Placed on web site 09/04/2025

Introduction OVERVIEW

Figure 2-6 Personal Injury Collision Plot

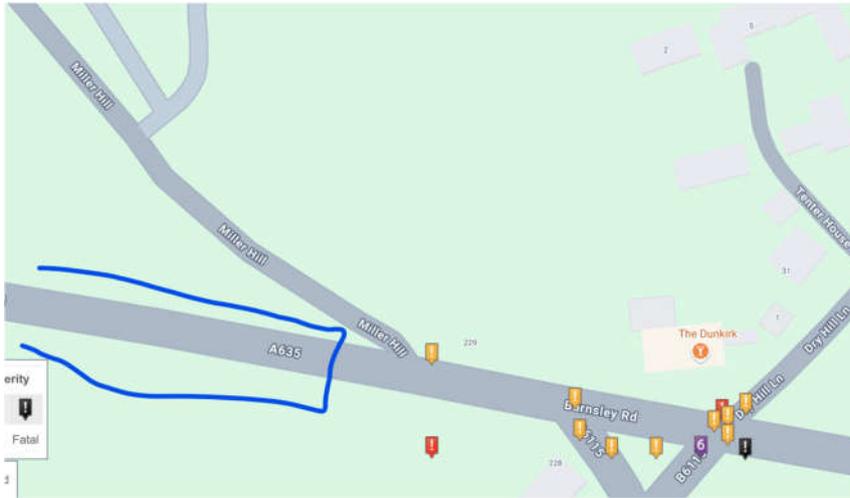
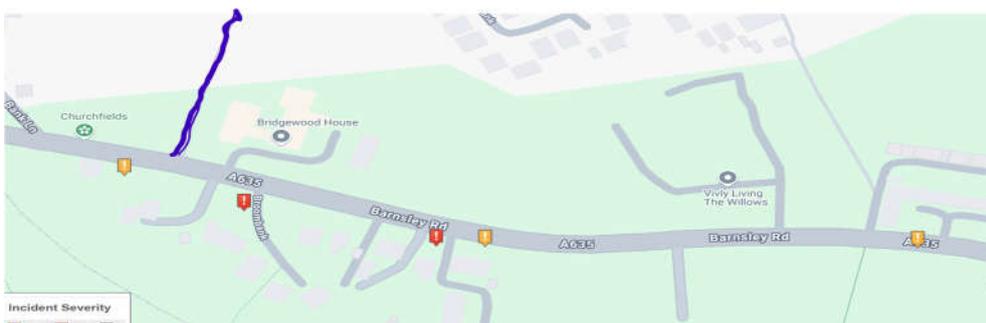
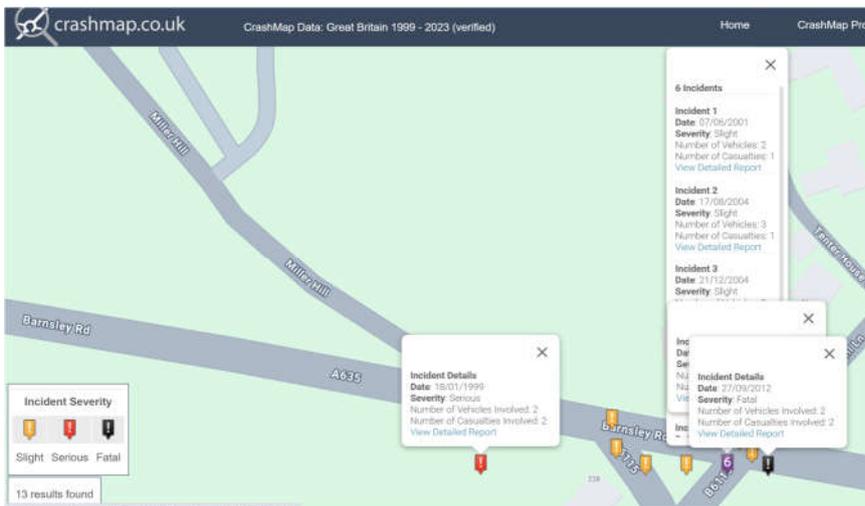
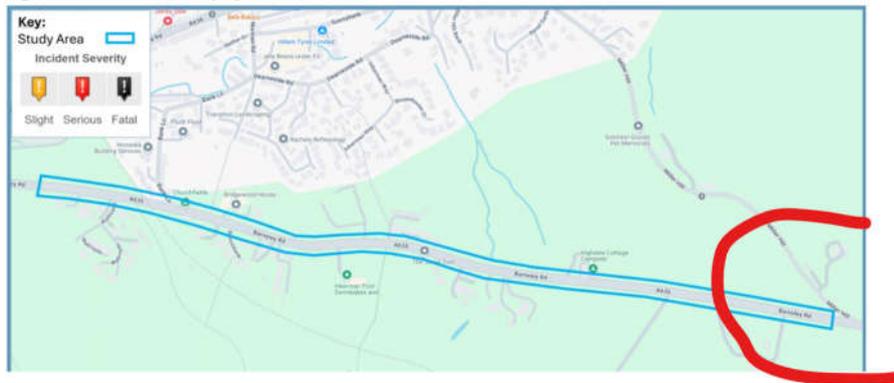
The report is a case of selective information, conveniently the study stops short of the five [5] way junction at The Dunkirk where there are numerous incidents and lots of near misses

The report Crash analysis fails by stopping short a matter of 10metres so not to include the 5 way Dunkirk Junction accident stats... this is misleading
